Dell™ PowerEdge™ 2900 Systems Information Update

This document provides updated information for your system on the following topics:

Figure 1. Removing the System Board

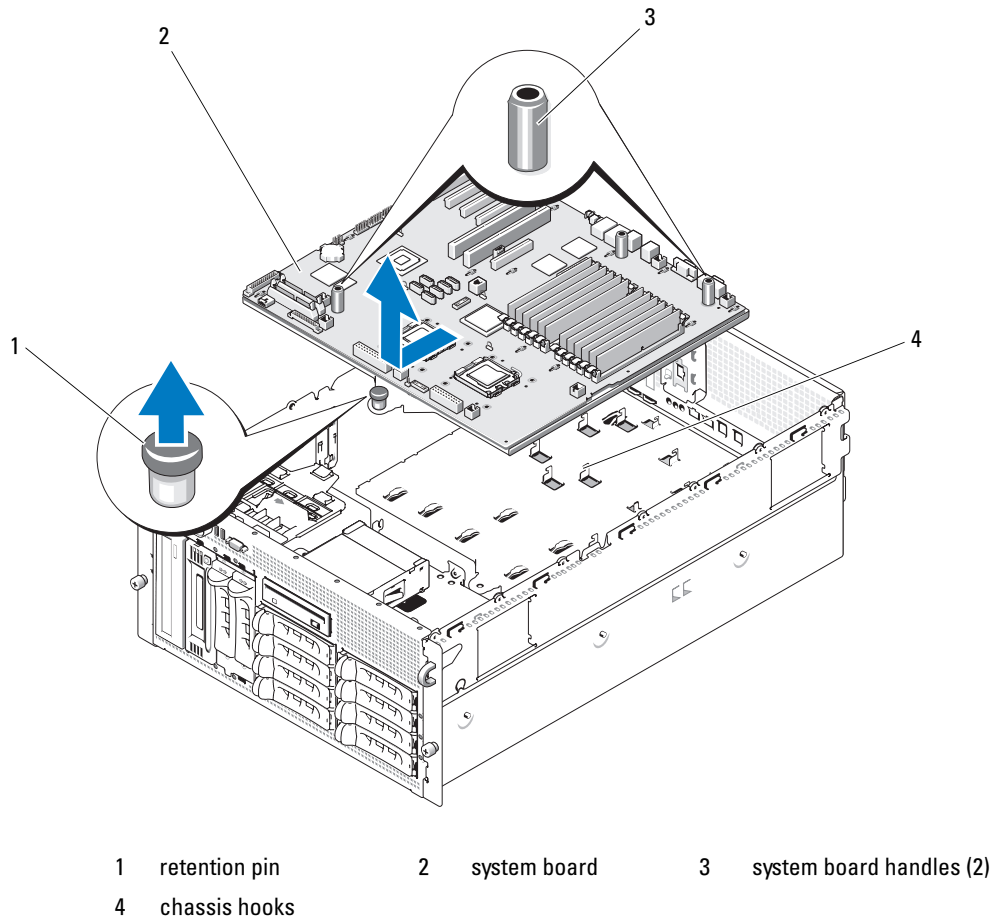
The procedure given in the *Hardware Owner's Manual* to replace the system board has been updated. When removing or installing the system board, lift or hold the system board by the retention pin and the system board handles (see Figure 1).

**NOTICE:** To avoid damage to your system board, do not lift the system board by the memory module retention brackets or by any component on the system board except for the system board handles.
